# AGENDA PACKET

# FEBRUARY 20, 2024 MEETING Part 1 of 2

**AGENDA**

Tuesday, February 20, 2024

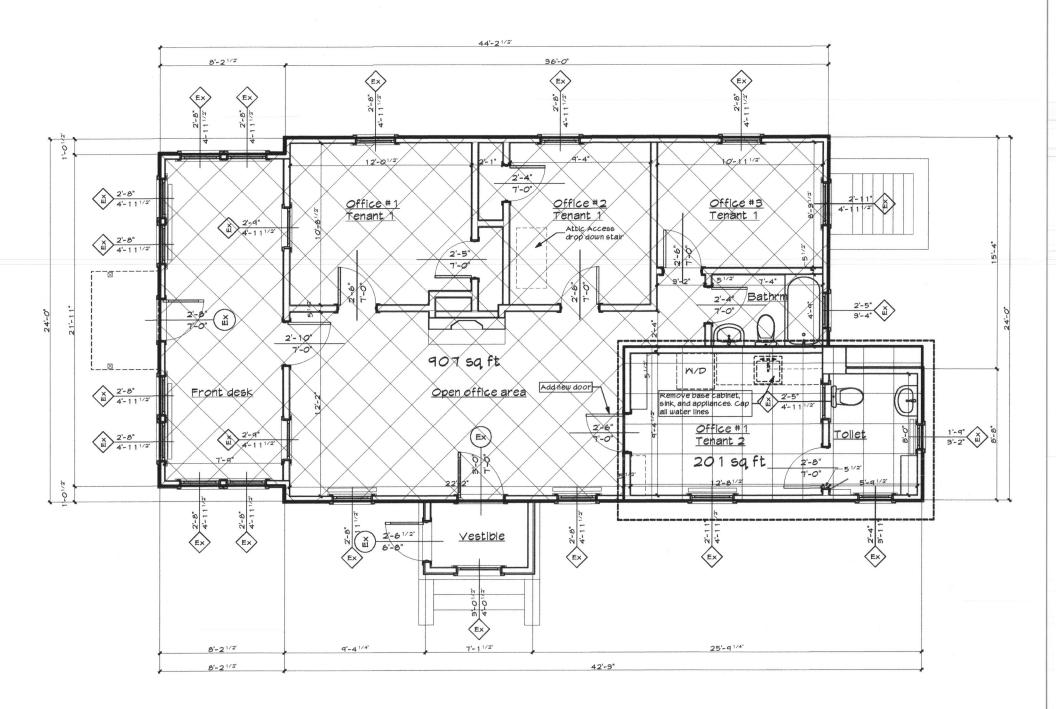
5. Gravel/asphalt extends to, over, or in close proximity to the front and side property lines, leaving little to no landscape buffer. The minimum landscape buffer setback shall be illustrated on the plan. It is recommended that the buffers be reestablished.

6. The limits of the storage area should be clearly defined by a permanent physical barrier to prevent future encroachment/expansion. Consider fencing, curbing, large stone boulders, or a combination thereof.

Applicant looks to the Planning Board for guidance.

Applicant looks to the Planning Board for guidance.

GRASSCRETE FOUNDATION DETAILS
N.T.S.

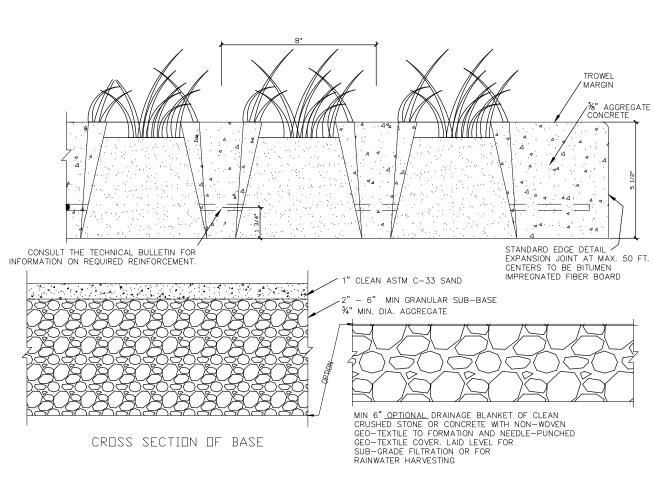
11. Provide construction details for the gravel driveway and parking area.

The applicant has revised the proposed driveway construction to include grass-crete pavers for its entirety. The detail should be revised to specify the layer thickness of the granular subbase depth.
